Alabama State Port Authority
Addendum to R&P or Specification Booklet

Project Name Berth Bed-Leveling On-Call

Project No. TBD **Task No.** 1 **Addendum No.** 1

DWG BY:	DATE:	REVISIONS	SCALE:
WEJ	5/12/26	BY: DATE: BY: DATE: BY: DATE:	1=200
CHKD. BY:	DATE:	WEJ 6/8/26	DRAWING NO.: XXXXX-22

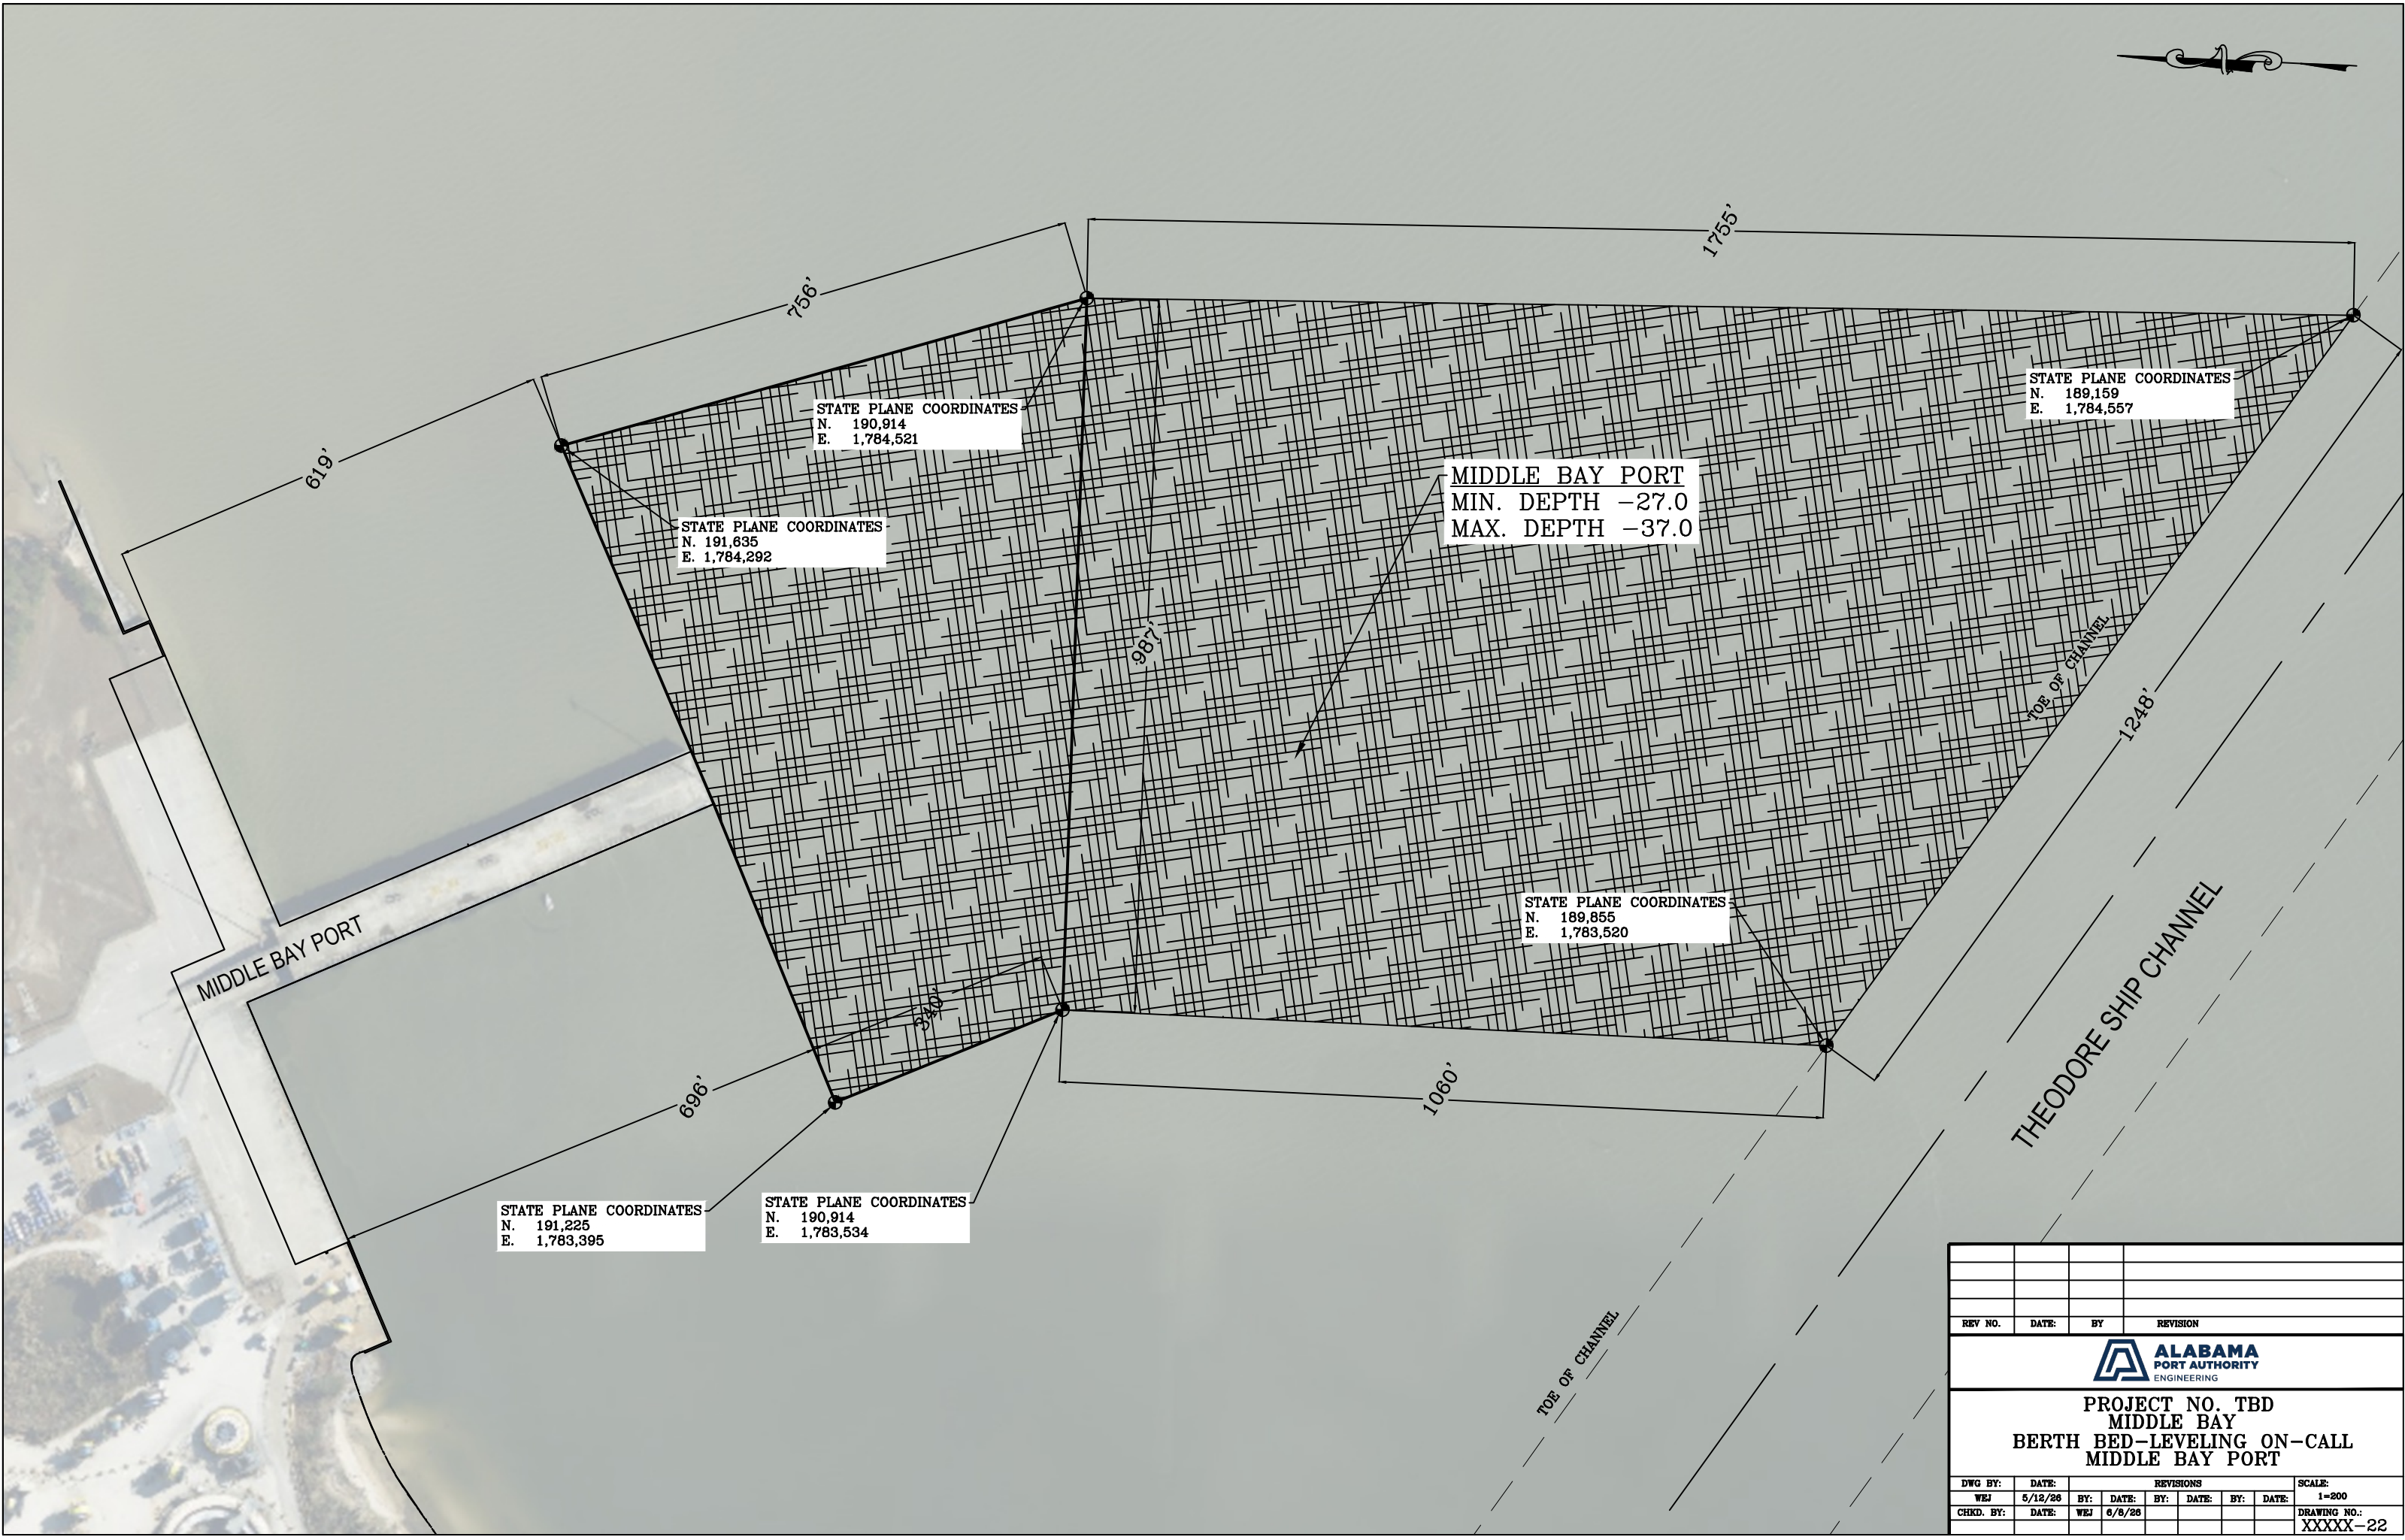
3.	<p><u>Attachments</u></p> <ul style="list-style-type: none"> ▪ Drawing No. XXXXX-22, Middle Bay Port (Revision date 6/8/26)

MIDDLE BAY PORT
 MIN. DEPTH -27.0
 MAX. DEPTH -37.0
